City of Ryde Submission

15-21 Cottonwood Crescent, Macquarie Park
SSD-940006708

Council File reference: COR2025/484/6
Submission Date: 21 April 2026

A comparison between the previous DA scheme (HOB:65m, FSR:4.5:1) and the SSD proposal (HOB:205.5m, FSR:14.5:1)(**new FSR 16.8:1**)

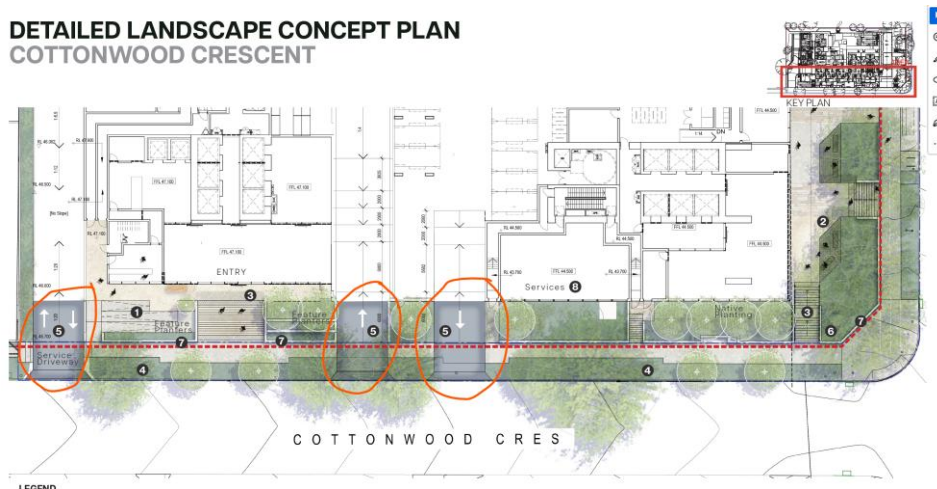
The proposed scheme includes two towers with a minor height variation and an 18 m building separation. Council notes a considerable increase in overall building bulk compared to the previous DA scheme, particularly building depth.

- The **Cottonwood tower** has an approximate depth of **26 m**.
- The **Waterloo tower** has an approximate depth of **28 m**.

These larger floorplates appear to have been maximised to achieve a high GFA. Council is concerned about the resulting impacts on design quality and residential amenity, including:

- reduced solar access for apartments and communal open space,
- limited opportunities for natural ventilation at podium levels.

Council also has concerns regarding potential **wind, visual, and overshadowing impacts** on the public domain, communal open spaces, neighbouring residential areas, and the broader precinct due to the excessive building height and built form.

- Reduce building height, bulk and depth and increase tower separation to improve solar access, natural ventilation and residential amenity as well as mitigating visual, wind, noise and other environmental impacts.

- Increase building separation to min. 24 metres (currently 18 metres) to comply with the Apartment Design Guide.
- Revise the layouts to increase the number of ADG compliant cross-ventilated apartments, particularly to the podium levels.

DETAILED LANDSCAPE CONCEPT PLAN COTTONWOOD CRESCENT

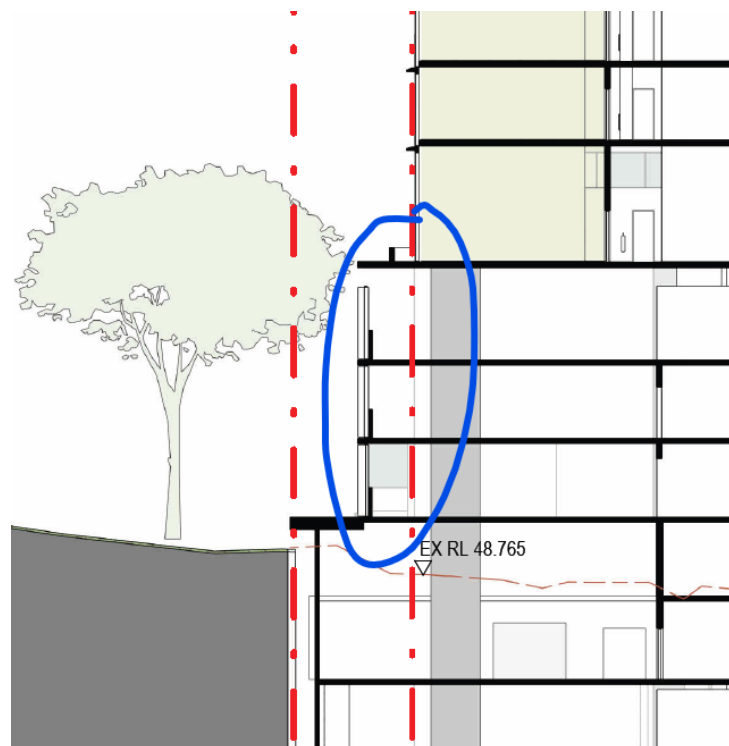
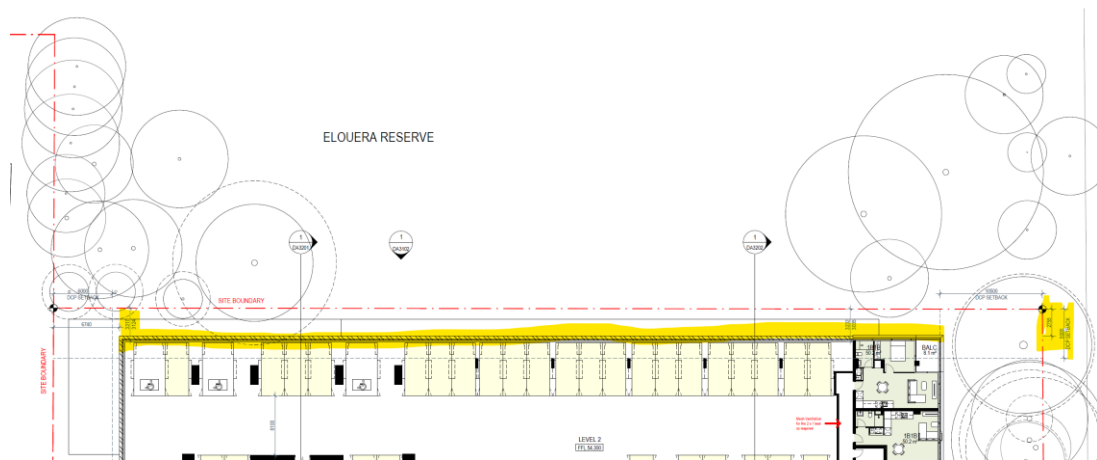
Varied setbacks are proposed along the western boundary adjoining Elouera Reserve. The podium levels (Level 1-3) provide setbacks of less than 3 m, which does not comply with the minimum 5 m setback required under the Ryde DCP. It also presents a solid wall as an interface with Elouera Reserve, raising safety concerns that require a CEPTED approach.

It requires design considerations to minimise visual and environmental impacts from podium car parking, and provide better interfaces with Elouera Reserve. It is recommended that all carparking is located below ground to improve the interface with Elouera reserve.

TREE REMOVAL / RETENTION PLAN

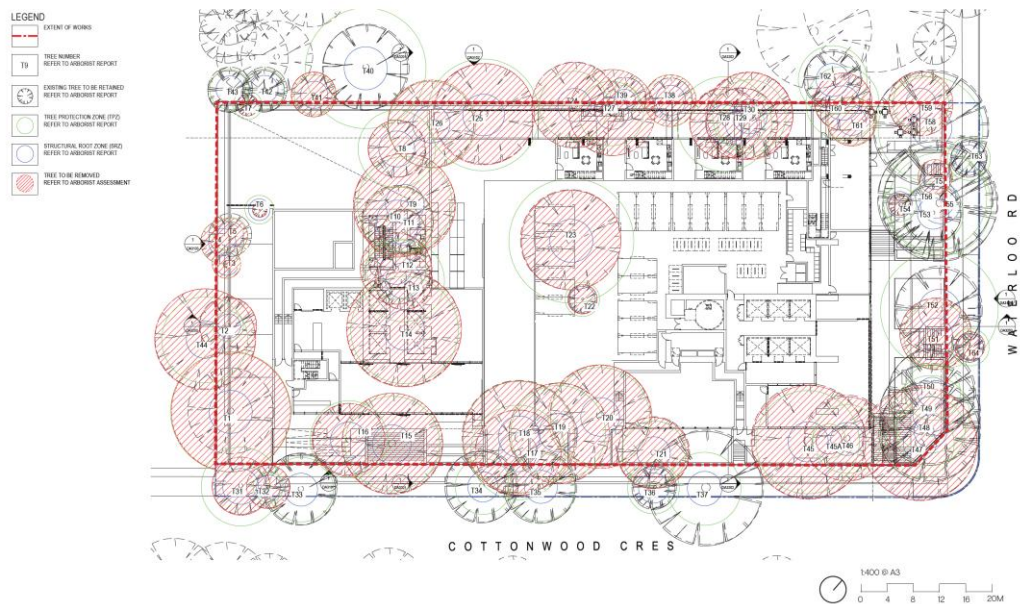
Existing mature trees along site boundaries currently provide shade and environmental value. The provided tree removal and retention plan indicates that most trees will be removed. All mature trees should be retained to the street edge at both Cottonwood Crescent and Waterloo Rd. Council requires a detailed arborist report for the removal of any existing mature trees.

DEEP SOIL STRATEGY

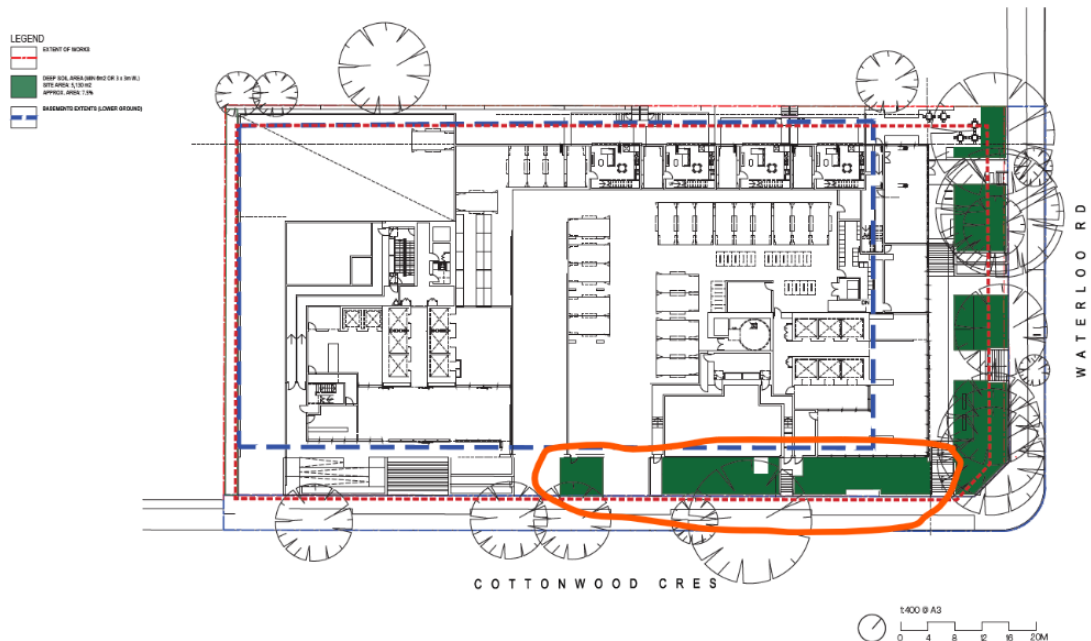
The ADG requires deep soil areas with a minimum dimension of **6m at either side, and a total deep soil provision of at least 7% of the site area.**

Deep soil zones along Cottonwood Crescent fall within the 5m building setback area and therefore:

- do not meet the minimum dimension, and
- fail to achieve the minimum 7% requirement.

11:00am (65m DA scheme)

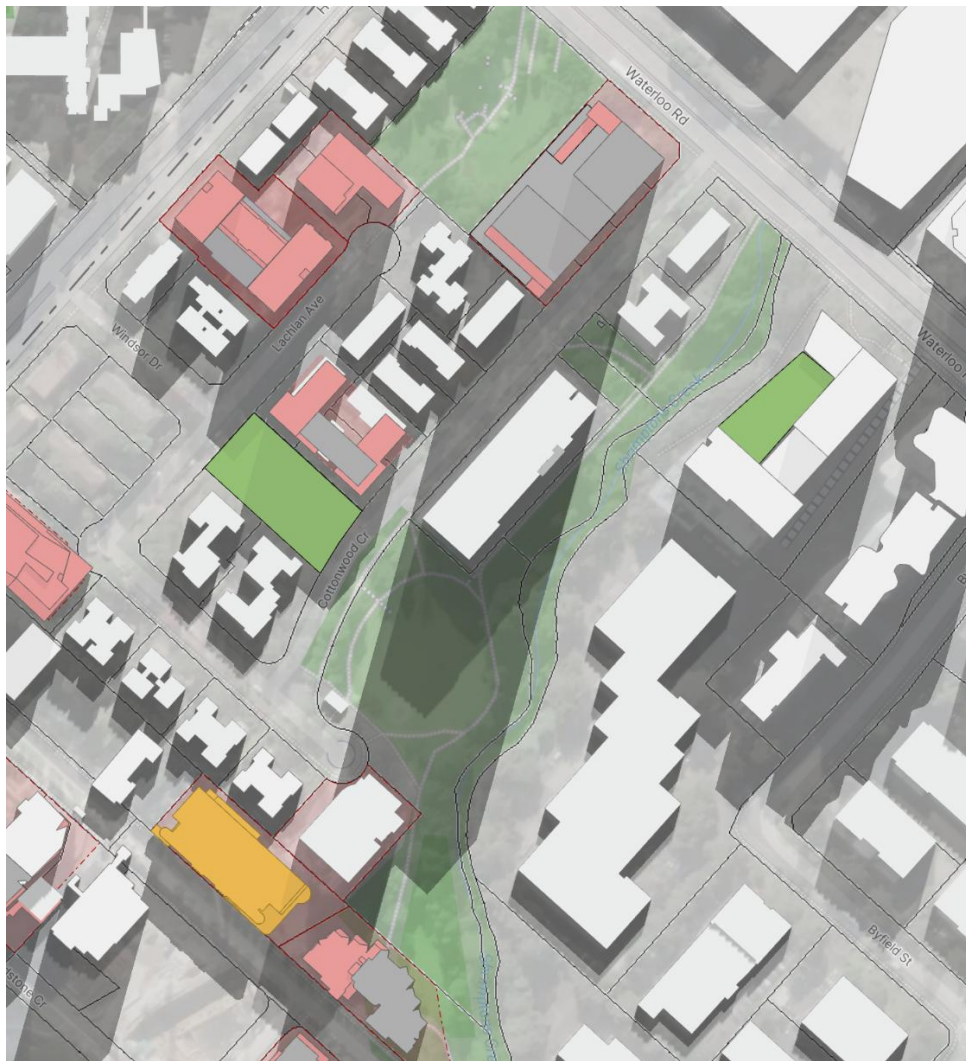
Impact on nearby open space. No additional shadow analysis diagrams provided for review. Previous documents demonstrated that a 65m building height produced no additional overshadowing to Wilga Park, while the proposed 205.5m height casts additional overshadowing to Wilga Park from 9:35am – 12:15pm on 21 June.

The proponent argues this reserve is currently significantly overshadowed. This should not be justification for making the situation much worse where the development will result in Cottonwood Reserve being almost completely overshadowed through the winter period.

It is noted that the proposal will significantly overshadow the Shrimpton's Creek area which results in it barely achieving the solar access requirements for public open space. There is also a significant impact on the solar access to Wilga Park up until 12 noon through the winter period. This will significantly impact on the amenity of these spaces for the broader community.
